**TOWN OF HARVARD
ZONING BOARD OF APPEALS AGENDA
WEDNESDAY, DECEMBER 6, 2023 @ 7:00pm via ZOOM**

Reference: Peer Review - Notice of Intent (NOI)
MassDEP File No. 177-0733
The Village at Robin Lane
Old Mill Road at Ayer Road
Harvard, Massachusetts
B+T Project No. 3241.04

CHAPTER 40B RESIDENTIAL DEVELOPMENT

THE VILLAGE AT ROBIN LANE

40B RESIDENTIAL DEVELOPMENT
 EXISTING CONDCTIONS PLAN

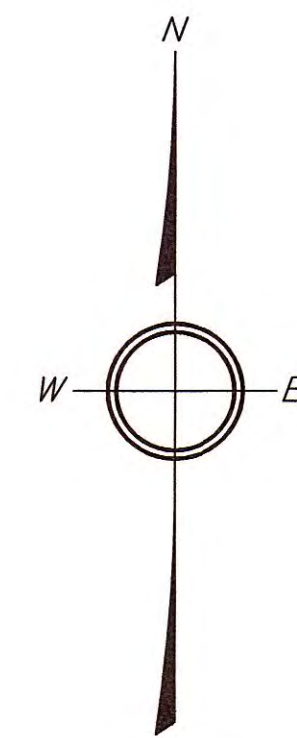
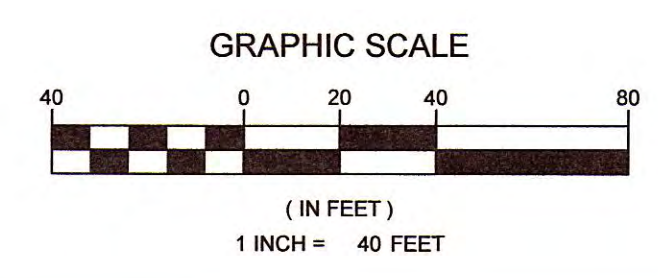
9. There appears to be a minor discrepancy in the depiction of the FEMA Zone AE elevation on the plan and how it is depicted in the Flood Insurance Rate Maps (FIRMs).

The site plans depict this Zone AE as Elevation 235.5 throughout the Property, but there is an on-site transect on the FEMA panel down to 235.4 (Panel No. 25027C0312E). While this is a minor discrepancy, we note it for the administrative record as the elevation depicts the boundary of Bordering Land Subject to Flooding (BLSF) and request that it be evaluated and corrected.

9. There appears to be a minor discrepancy in the depiction of the FEMA Zone AE elevation on the plan and how it is depicted in the Flood Insurance Rate Maps (FIRMs). The site plans depict this Zone AE as Elevation 235.5 throughout the Property, but there is an on-site transect on the FEMA panel down to 235.4 (Panel No. 25027C0312E). While this is a minor discrepancy, we note it for the administrative record as the elevation depicts the boundary of Bordering Land Subject to Flooding (BLSF) and request that it be evaluated and corrected.

NO.	DATE	BY	APP.	REVISION DESCRIPTION
2	11/16/23	LT	NMP	FEMA ZONE AE UPDATE
1	9/20/23	LT	NMP	PEER REVIEW COMMENTS

Acknowledged. Although the proposed development does not encroach upon the FEMA Zone AE, the site plan shall be revised to provide notation for the section of the FEMA Zone AE Elevation 235.5 and Zone AE Elevation 235.4.

SILT FENCE / STRAW WATTLE BARRIER
 TYPICAL CROSS SECTION
 NOT TO SCALE

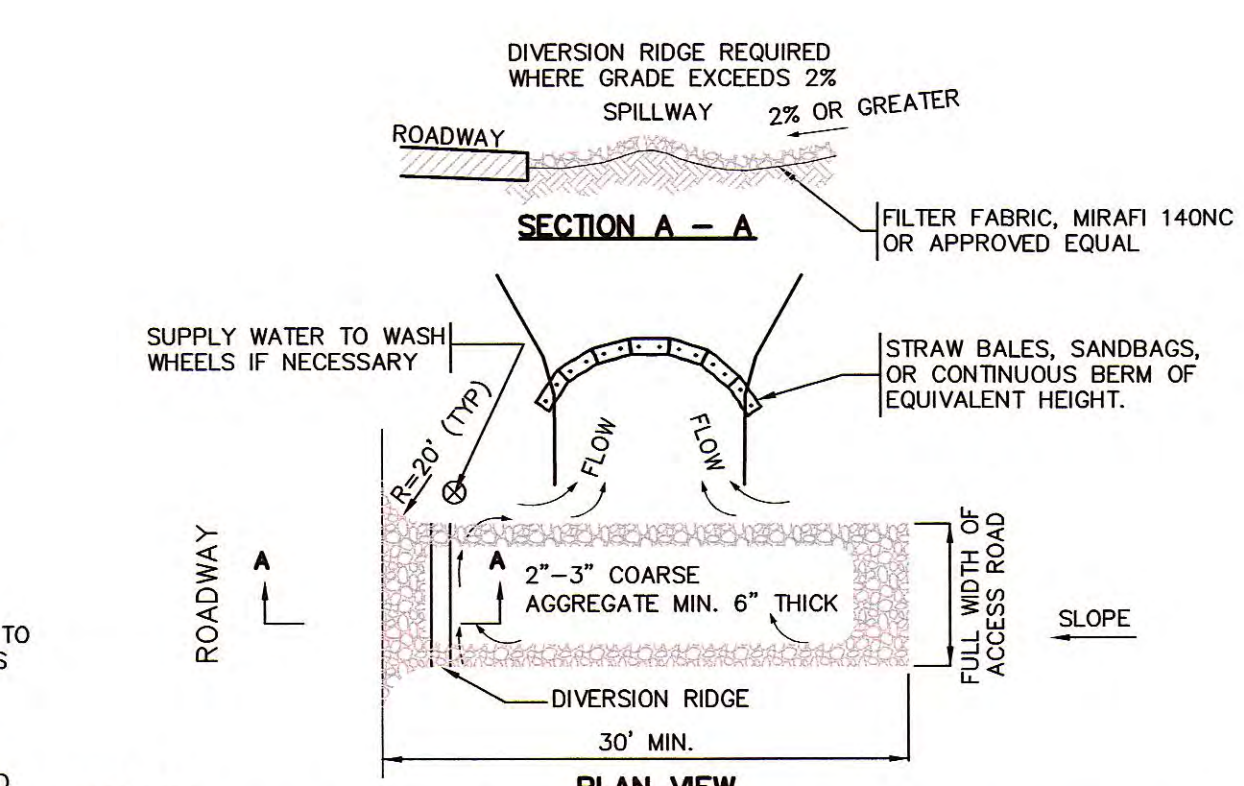
10. The site plans refer to the use of hay bale BMPs for erosion and sediment control. We request that the Applicant consider the use of straw bales rather than hay given the propensity of the latter to contain seed mass of invasive species.
11. The proposed dewatering detail (Sheet C6.1) contains the use of flocculant crystals on the bed of hay bales. We request that the Applicant consider avoiding the use of flocculants, especially given the proposal to install three drinking water supply wells in the down-gradient area. Further, additional monitoring requirements may apply to the project with the use of flocculants under the 2022 Construction General Permit (CGP).

10. The site plans refer to the use of hay bale BMPs for erosion and sediment control. We request that the Applicant consider the use of straw bales rather than hay given the propensity of the latter to contain seed mass of invasive species.

Agreed. The site plan shall be revised to replace hay bales with straw as recommended.

TEMPORARY DEWATERING STRUCTURE
 NOT TO SCALE

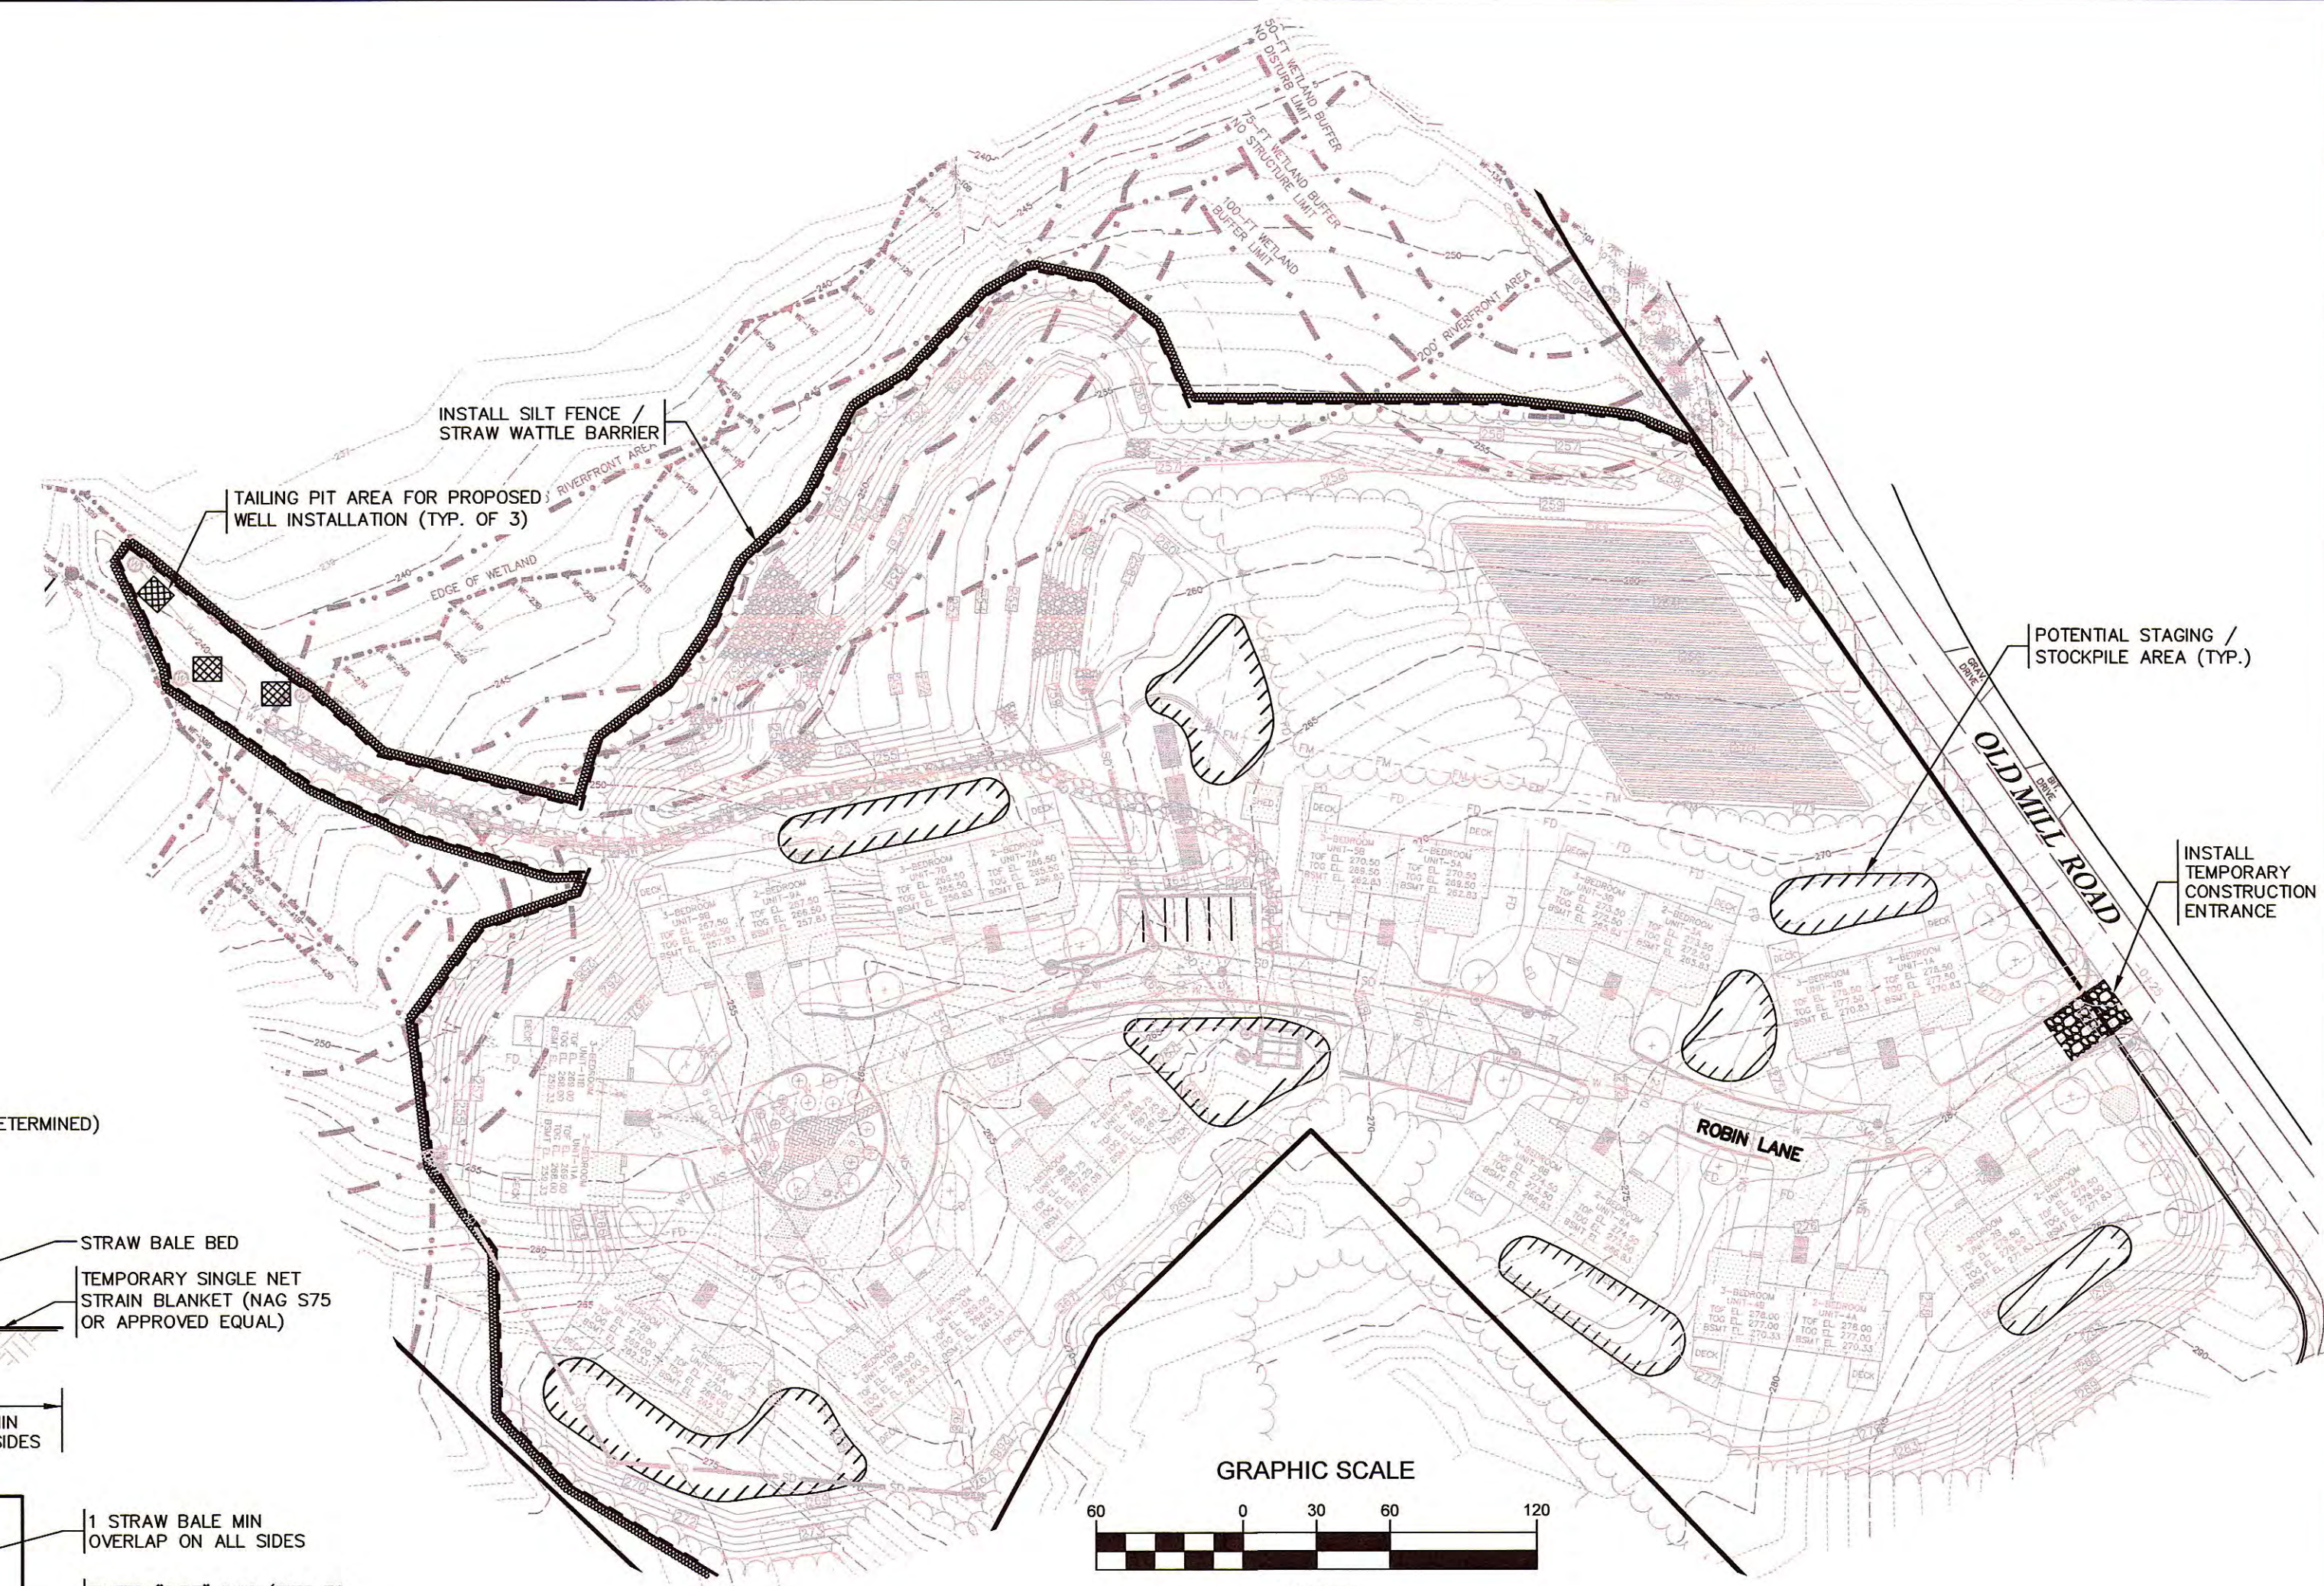
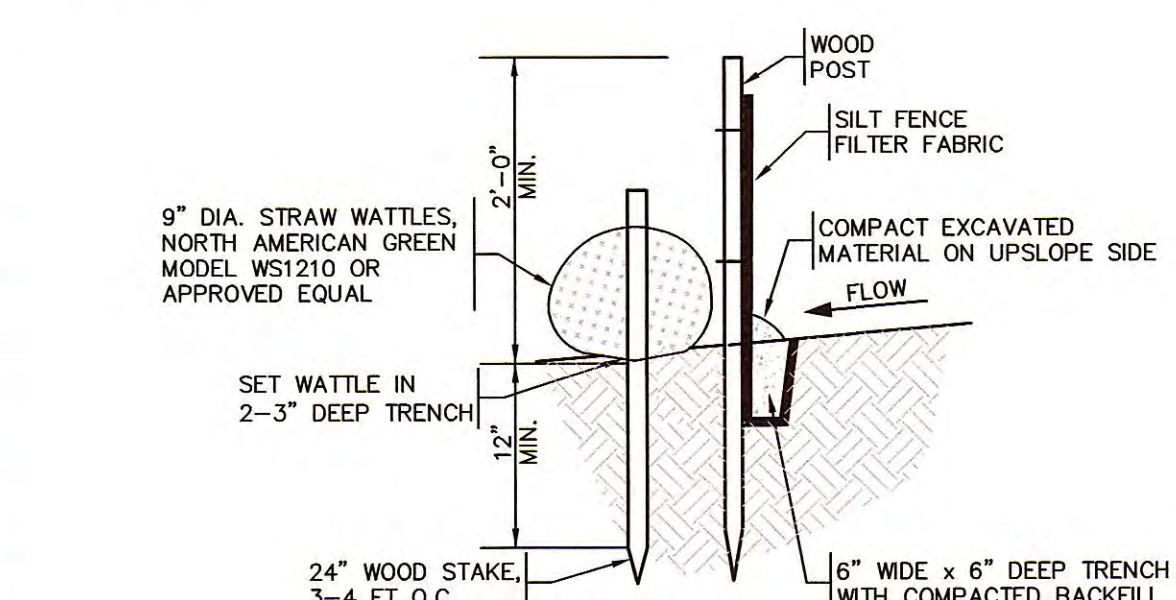
11. The proposed dewatering detail (Sheet C6.1) contains the use of flocculant crystals on the bed of hay bales. We request that the Applicant consider avoiding the use of flocculants, especially given the proposal to install three drinking water supply wells in the down-gradient area. Further, additional monitoring requirements may apply to the project with the use of flocculants under the 2022 Construction General Permit (CGP).

Agreed. The site plan shall be revised to remove the use of flocculant crystals and hay shall be replaced with straw as recommended.
